Development Review Comments

PAM2023-00149

Submission Review Comments

414 – 416 Hungerford Drive

PROJECT PLAN

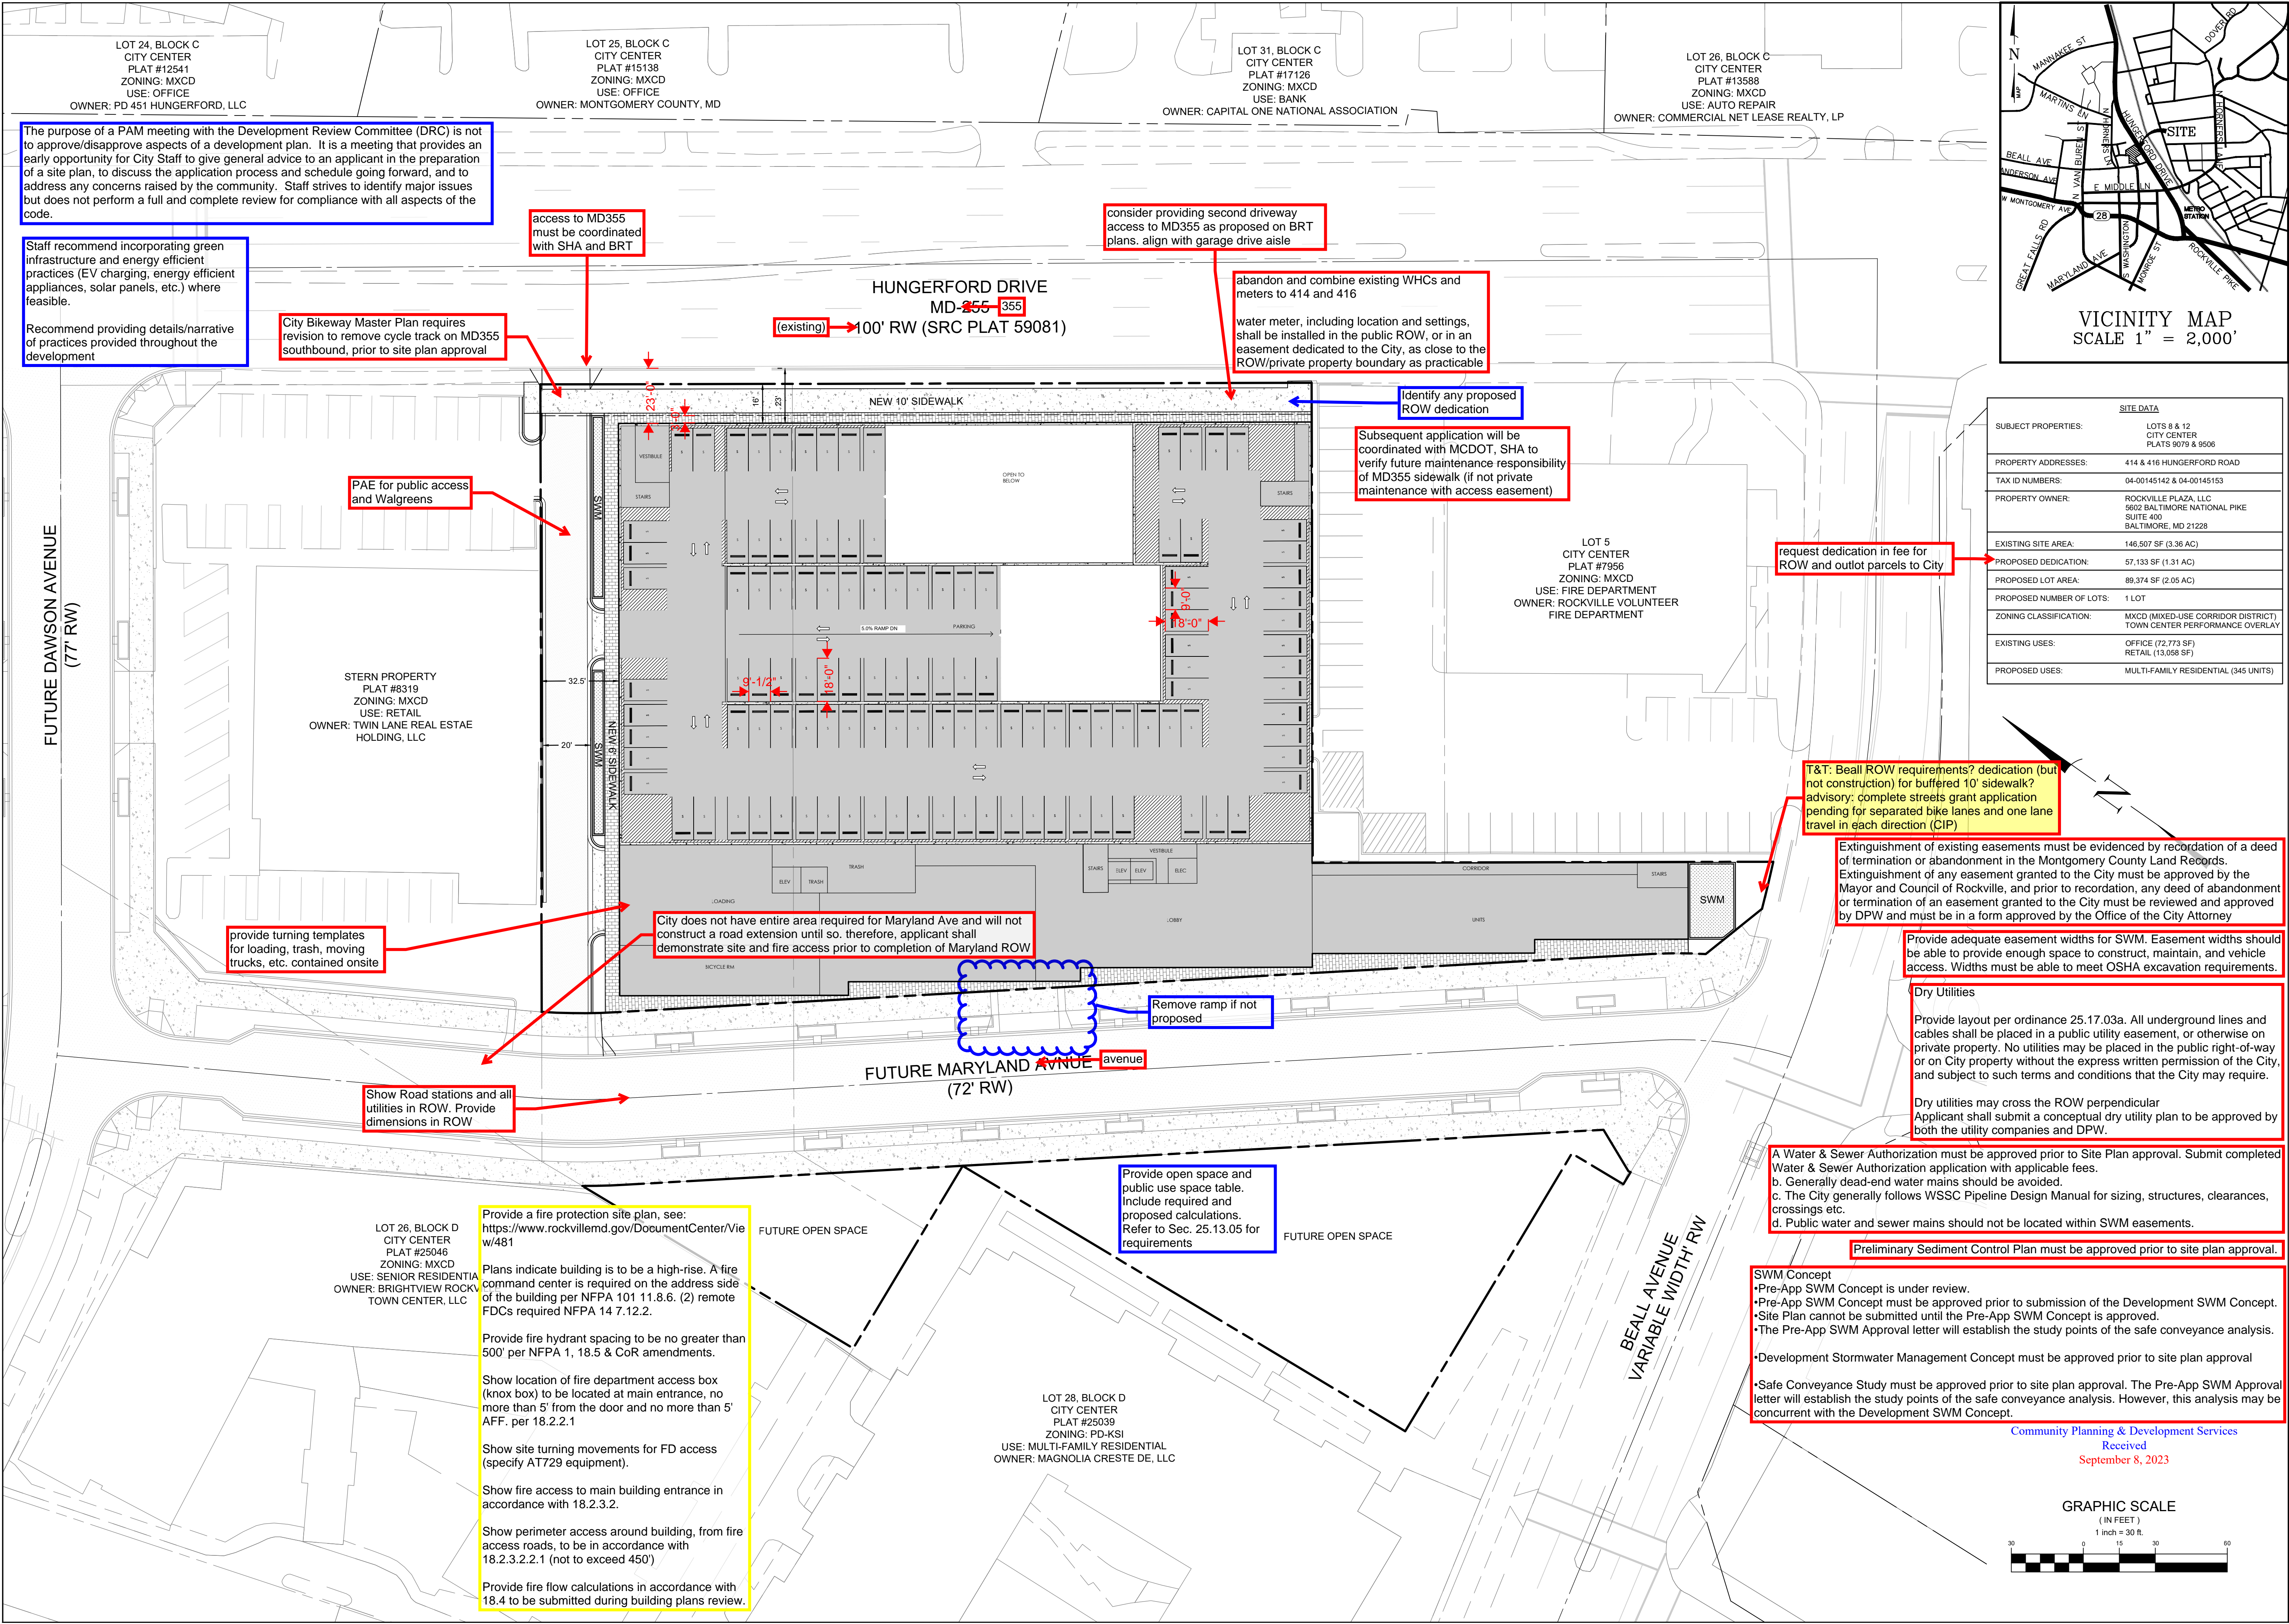
Staff recommend incorporating green infrastructure and energy efficient practices (EV charging, energy efficient appliances, solar panels, etc.) where feasible.

Recommend providing details/narrative of practices provided throughout the development

City Bikeway Master Plan requires revision to remove cycle track on MD355 southbound, prior to site plan approval

access to MD355 must be coordinated with SHA and BRT

consider providing second driveway access to MD355 as proposed on BRT plans. align with garage drive aisle

abandon and combine existing WHCs and meters to 414 and 416

water meter, including location and settings, shall be installed in the public ROW, or in an easement dedicated to the City, as close to the ROW/private property boundary as practicable

Identify any proposed ROW dedication

Subsequent application will be coordinated with MCDOT, SHA to verify future maintenance responsibility of MD355 sidewalk (if not private maintenance with access easement)

PAE for public access and Walgreens

request dedication in fee for ROW and outlot parcels to City

T&T: Beall ROW requirements? dedication (but not construction) for buffered 10' sidewalk? advisory: complete streets grant application pending for separated bike lanes and one lane travel in each direction (CIP)

Provide a fire protection site plan, see: <https://www.rockvillemd.gov/DocumentCenter/View/481>

Plans indicate building is to be a high-rise. A fire command center is required on the address side of the building per NFPA 101 11.8.6. (2) remote FDCs required NFPA 14 7.12.2.

Provide fire hydrant spacing to be no greater than 500' per NFPA 1, 18.5 & CoR amendments.

Show location of fire department access box (knock box) to be located at main entrance, no more than 5' from the door and no more than 5' AFF. per 18.2.2.1

Show site turning movements for FD access (specify AT729 equipment).

Show fire access to main building entrance in accordance with 18.2.3.2.

Show perimeter access around building, from fire access roads, to be in accordance with 18.2.3.2.1 (not to exceed 450')

Provide fire flow calculations in accordance with 18.4 to be submitted during building plans review.

Provide open space and public use space table. Include required and proposed calculations. Refer to Sec. 25.13.05 for requirements
